Mondol Fabrics Ltd. (Extension)

Nayapara, Kashimpur, Gazipur

7 November 2023

Building-8: Eight-storey (G+M+7) reinforced concrete (RC) building with two mezzanine floors inside the ground and 1st floor.

Material Specification in Design Report

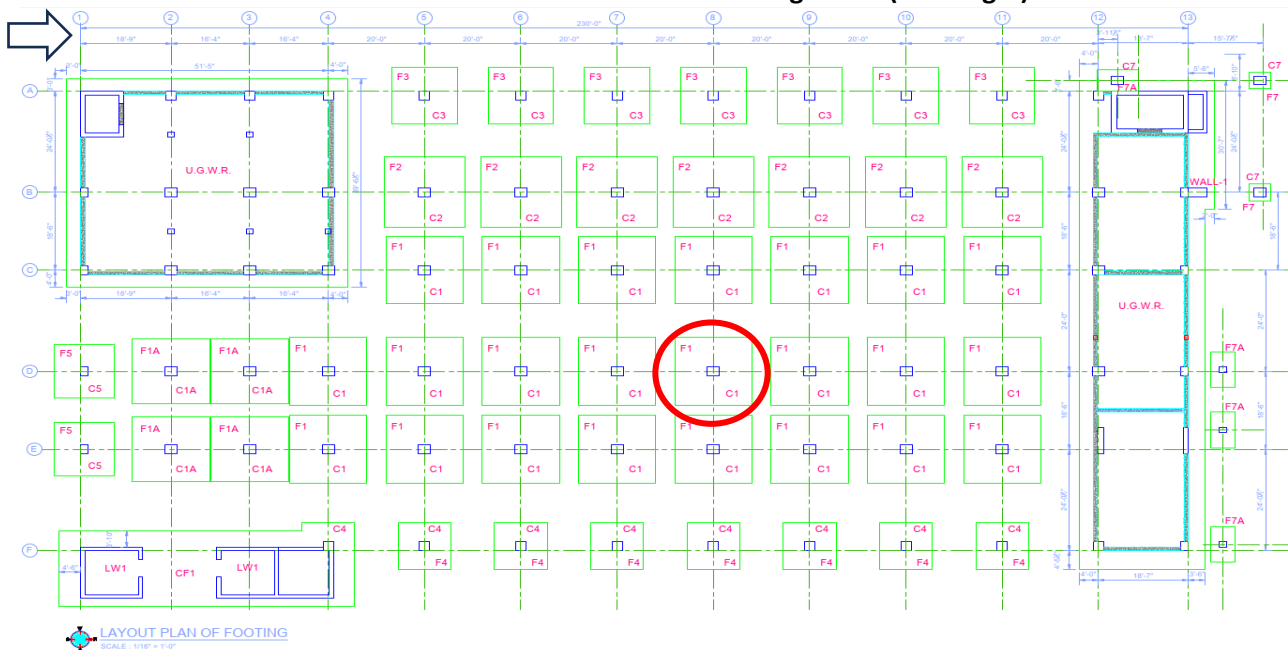
Observation 1: Lack of calculation of material strength in design report (Building-08).

Description: A set of design reports was available for Building-8 prepared following BNBC 2006. In the design report, the concrete strength has been considered of 3500 psi on cylinder test reports. The building engineer is required to verify the frequency of testing requirements as per BNBC (Part VI, Chapter 5, 5.12.2) and update the analysis & design report if required.

Bearing capacity consideration (30.48ksf) in the design report

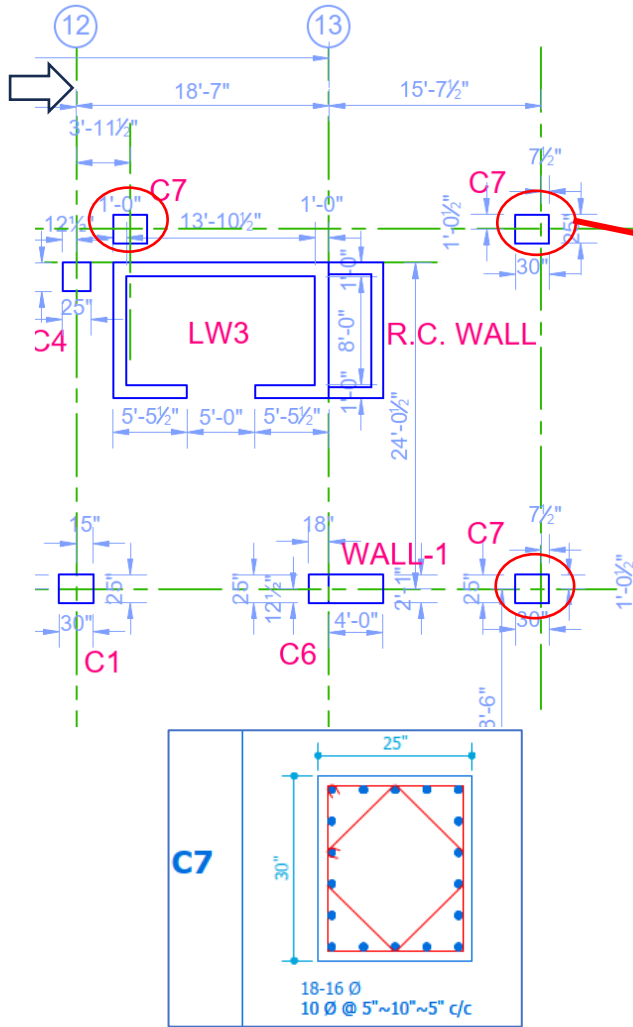
Description: The consideration of ultimate bearing capacity is not clear, cursory calculation from soil test shows less than the considered value. The building engineer is required to provide detailed clarification of specific sourcing of the values considered for the bearing capacity in the design report.

Column C7 (750X675) in drawing

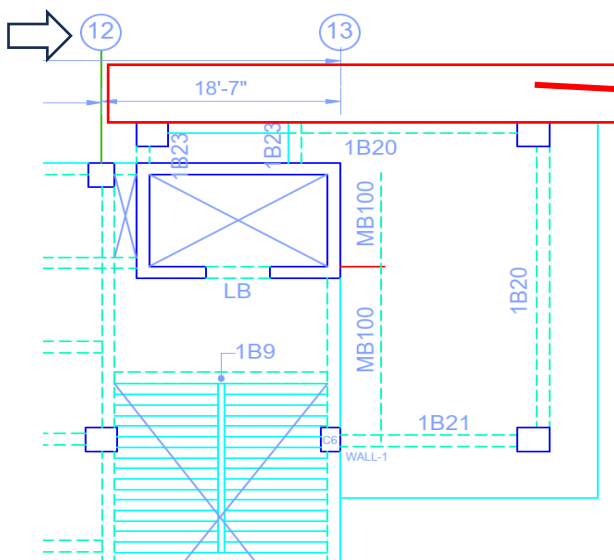
With plaster, 500X650 found on site

The extended corbel beam is not shown in the provided drawing

Description: Column C7 dimensions are different from the on-site condition. Also, beam layout and detail mismatches were observed. A building engineer is required to survey the whole structure and prepare the as-built drawing reflecting the on-site condition as well as update the design report.

Extended corbel beam was found on the 1st floor on-site with a concentrated loading steel bridge
